FINAL DRAINAGE PLAN

LORSON RANCH EAST FILING NO. 4

FEBRUARY 28, 2019

SF-19-0XX / EGP 18-002

DRAINAGE PLAN - NORTH AREA

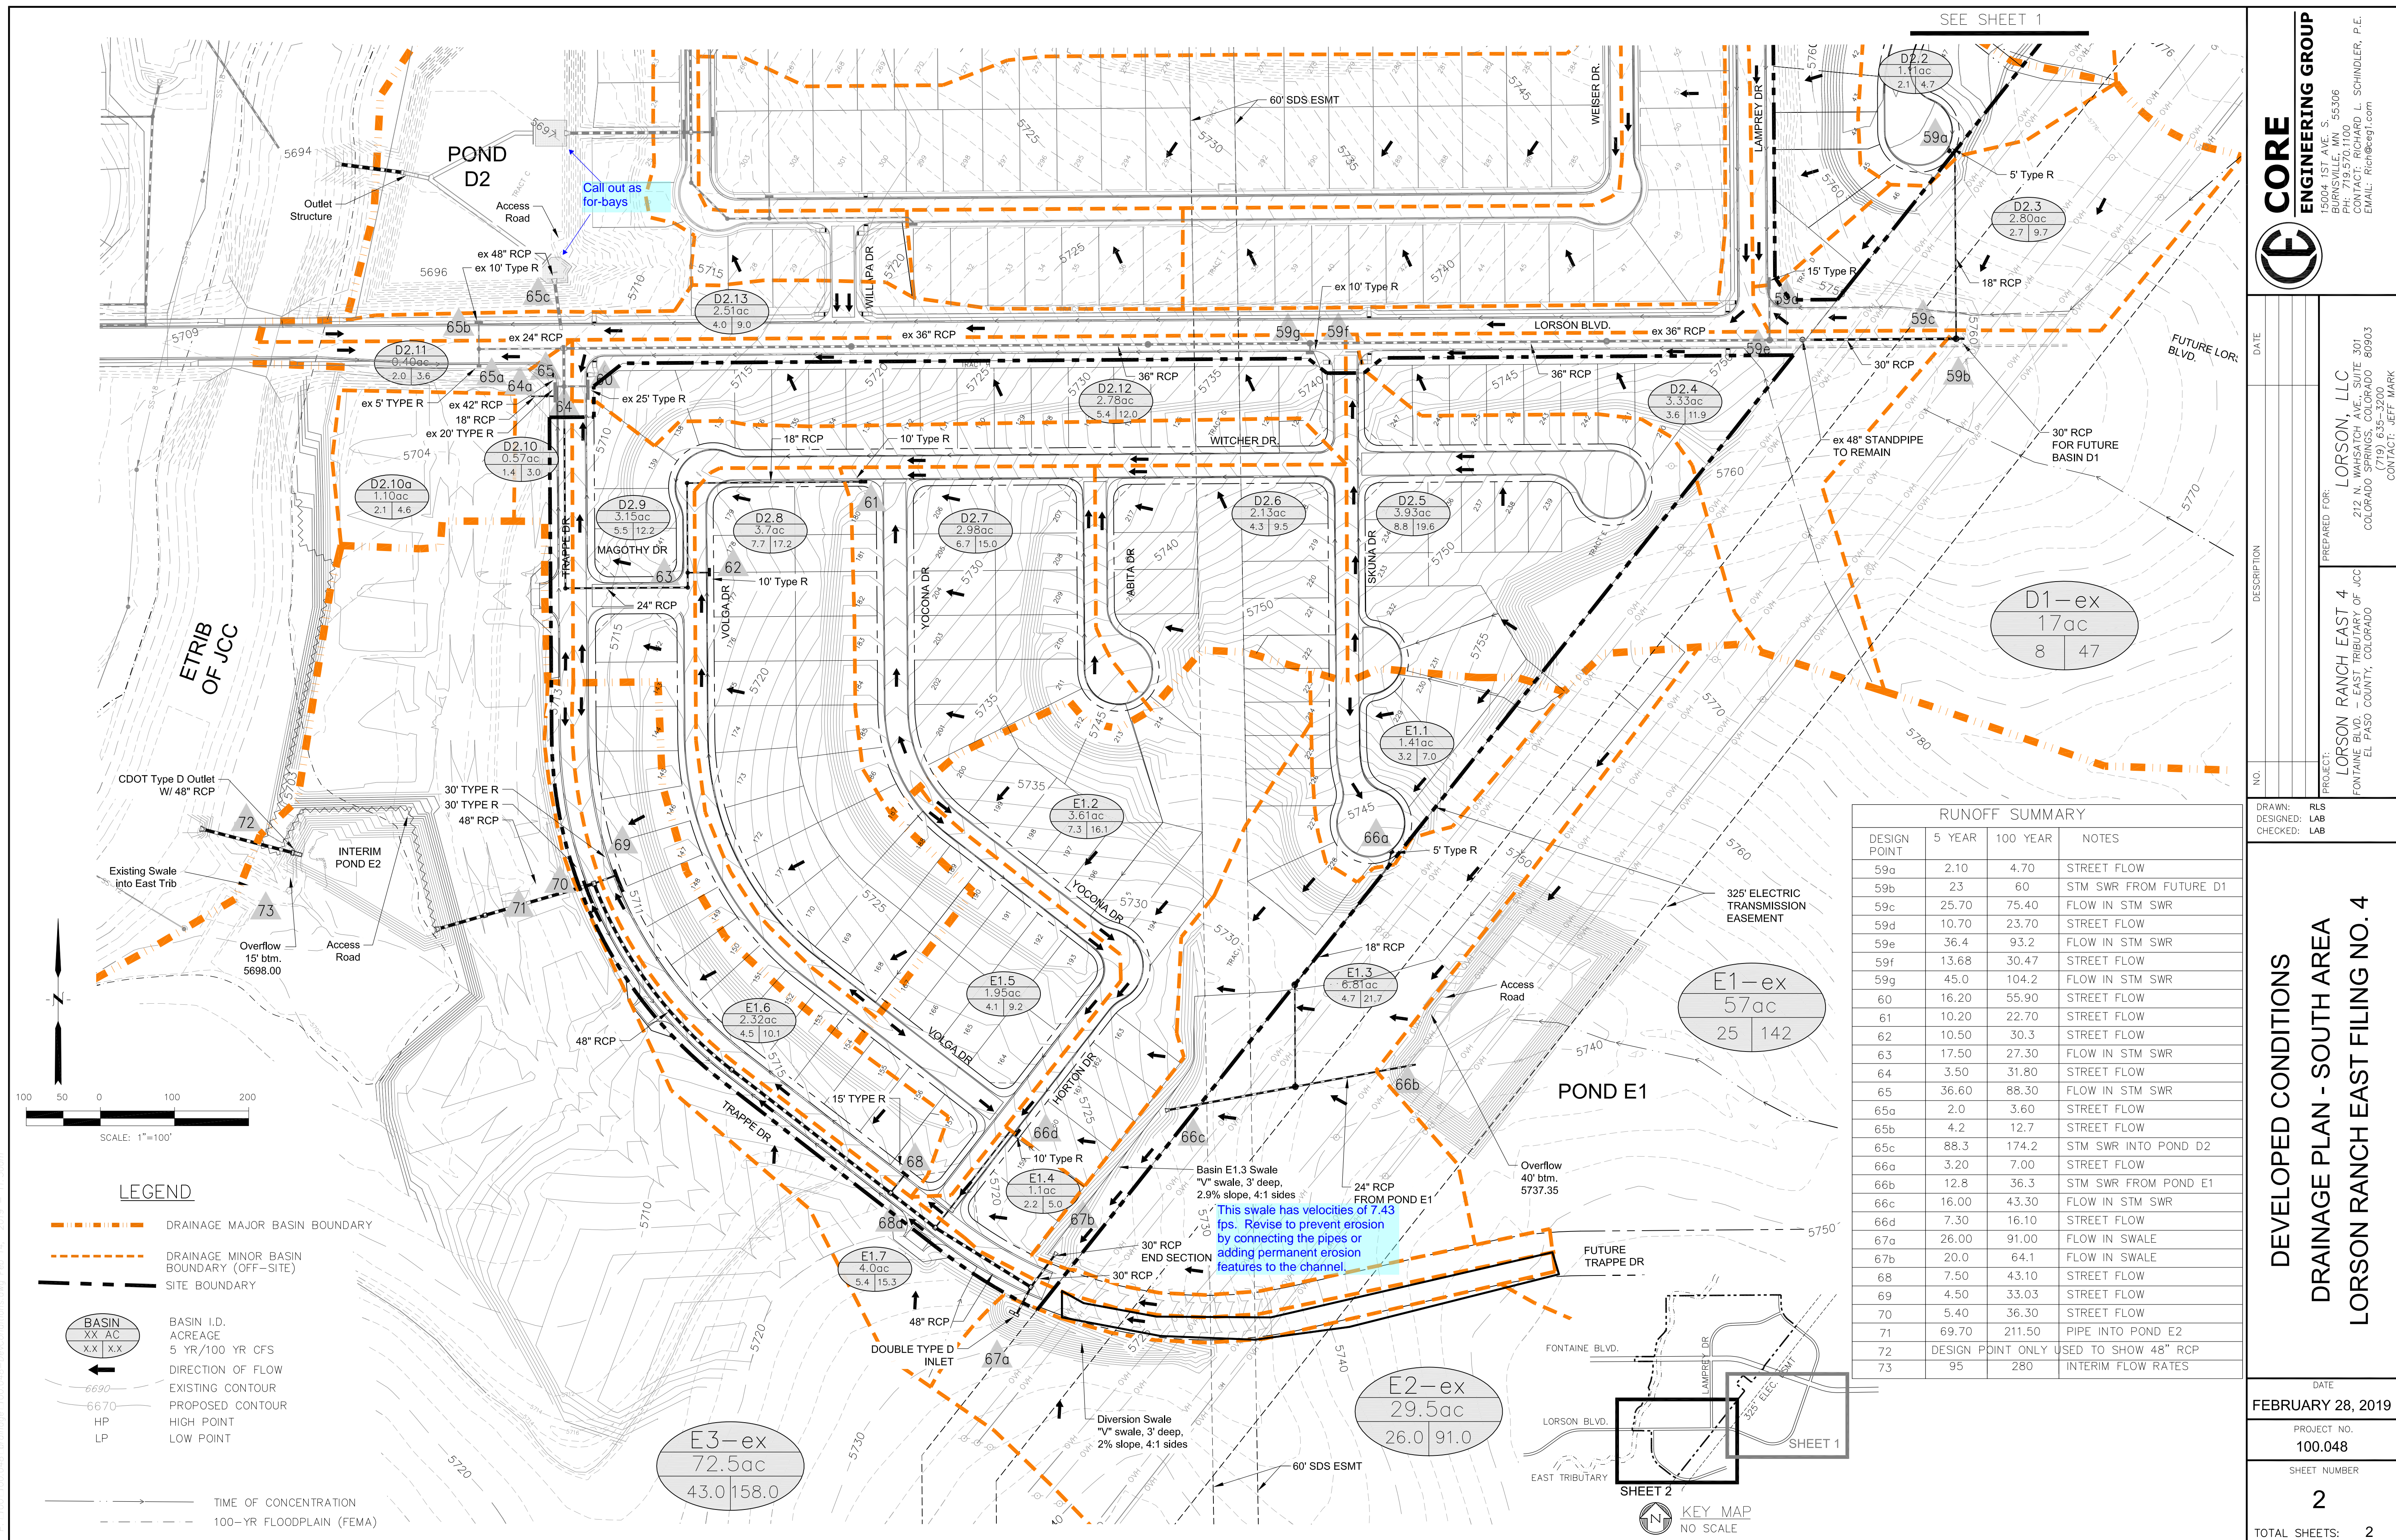
[Show design point 29 on the drainage plan.](#)

Show design point 29 on the drainage plan.

POND E2
SEE FINAL GRADING PLANS
FOR ELEVATIONS AND
LAYOUT

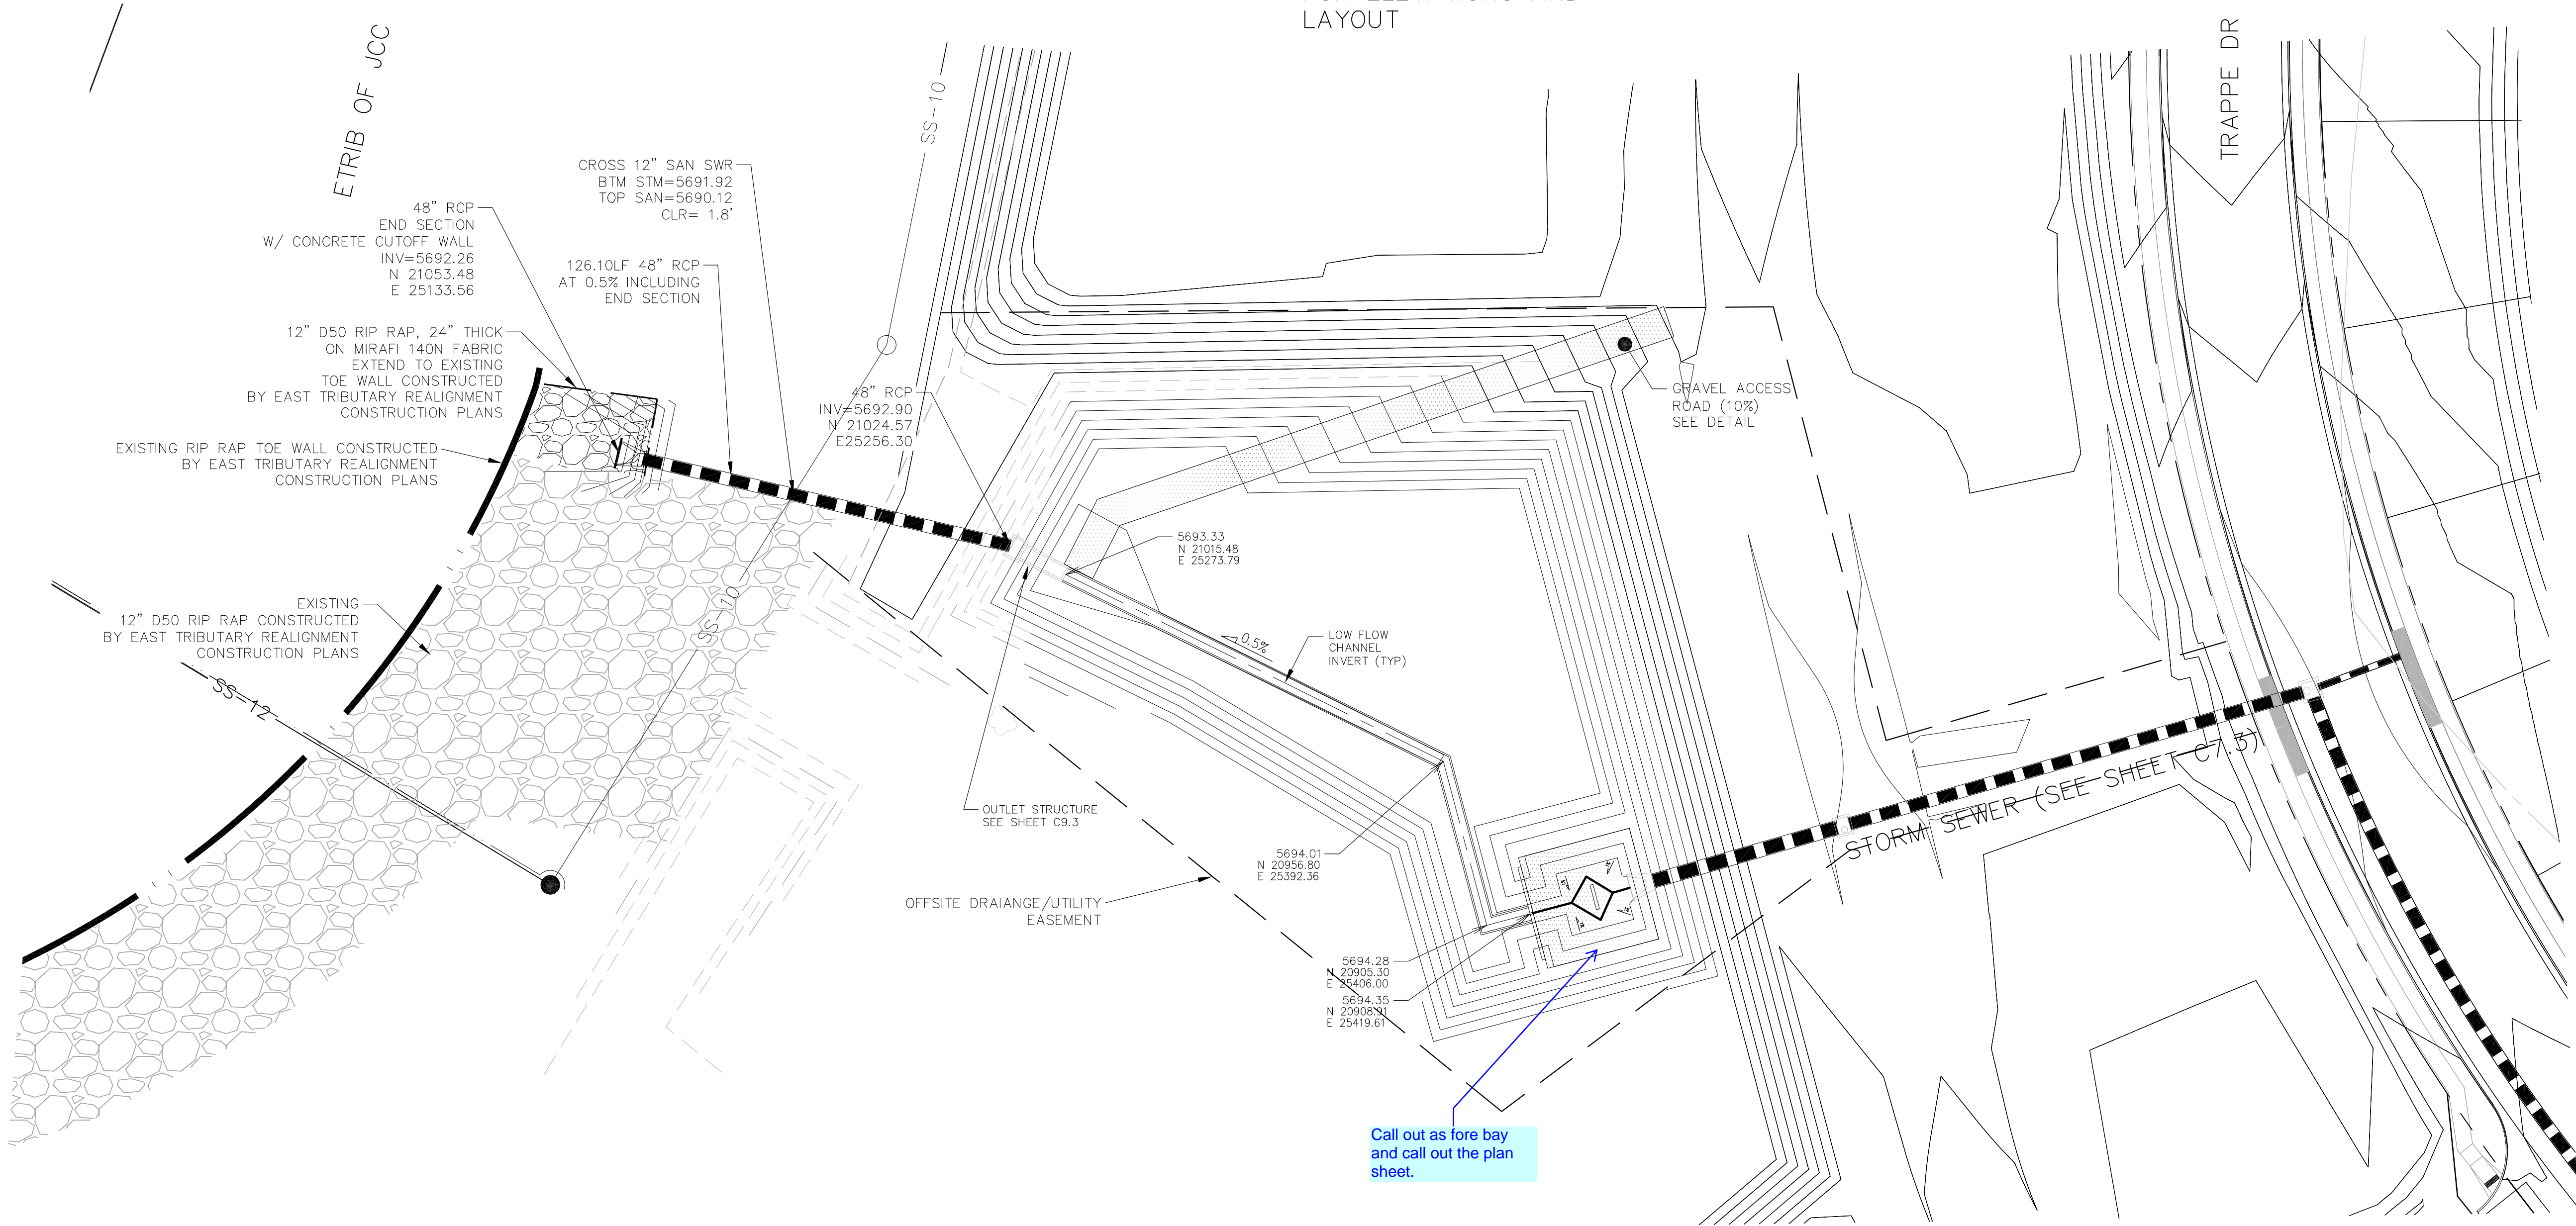
Provide forebay per details in Chapter 13 DCM
Volume 1 which has been adopted by El Paso
County.
